Project	IEEE 802.16 Broadband Wireless Access Working Group < http://ieee802.org/16 >	
Title	Corrections on Figures for SS ranging and network entry	
Date Submitted	2007-11-05	
Source(s)	Kanchei (Ken) Loa, Yi-Hsueh Tsai, Yung-Ting Lee, Hua-Chiang Yin, Shiann-Tsong Sheu, Youn-Tai Lee, Institute for Information Industry 8F, No. 218, Sec. 2, Dunhua S. Rd., Taipei City 106, Taiwan [add other co-authors here]	Voice: +886-2-27399616 Fax: +886-2-23782328 loa@iii.org.tw
Re:	IEEE 802.16j-07/043: "IEEE 802.16 Working Group Working Group Letter Ballot #28"	
Abstract	This contribution proposes to correct and merge the paragraphs in SS ranging and network entry in both transparent and non-transparent mode.	
Purpose	Text proposal for 802.16j Draft Document.	
Notice	<i>This document does not represent the agreed views of the IEEE 802.16 Working Group or any of its subgroups. It represents only the views of the participants listed in the "Source(s)" field above. It is offered as a basis for discussion. It is not binding on the contributor(s), who reserve(s) the right to add, amend or withdraw material contained herein.</i>

Corrections on Figures for SS ranging and network entry

This contribution

Figure 115a—Handling CDMA ranging code at a transparent RS

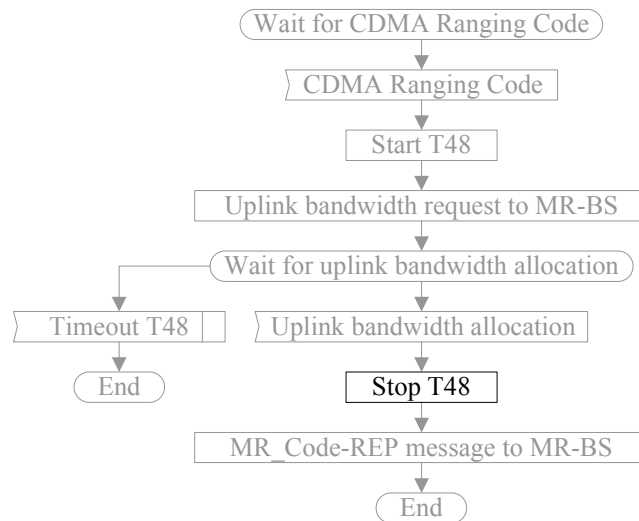
[Modified “the start/stop timer” in the following figures as indicated:]
